REMARKS

Appl. No. 10/767,703 Hansen, *et al.* Page 10 of 10

DRAWING AMENDMENTS:

The attached sheets of drawings include changes to Figs. 1 and 2. These sheets, which include Figs. 1-2, replace the original sheets including Figs. 1-2.

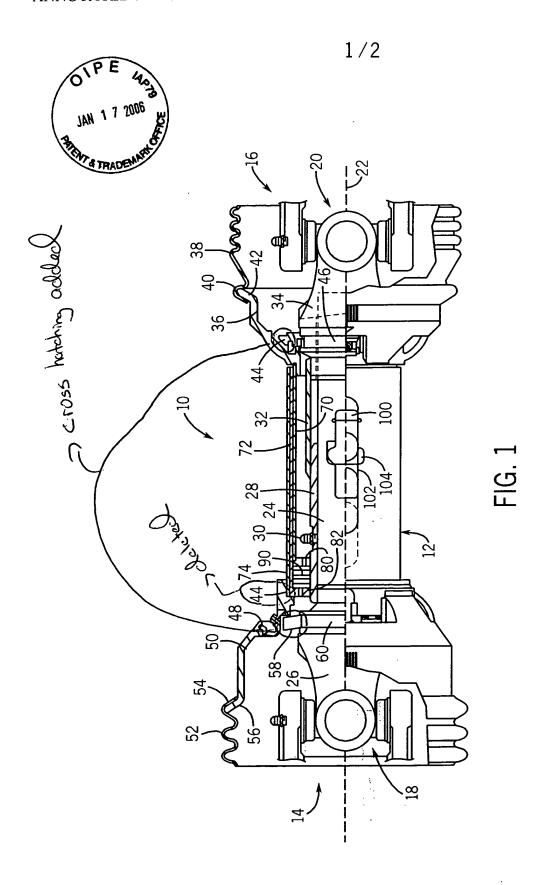
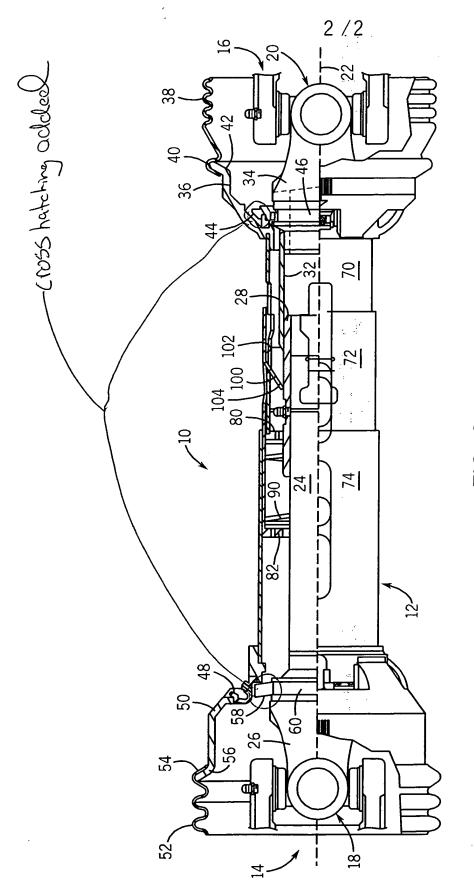
Specifically, the drawings are now shown with proper cross-hatching (alternating heavy and light diagonal lines representing plastic material) for bushings 44 and 48 to address point 2a in the Office action.

Regarding point 2b, Applicants have amended claims 3 and 13 to replace "acts against the inner guard sleeve to bias" with "biases." Fig. 2 shows that the spring 90 biases (as opposed to acting against) the center guard sleeve axially toward the outer guard sleeve.

An erroneous reference numeral 44 and its lead line were deleted from Fig. 1 to correct a clerical error.
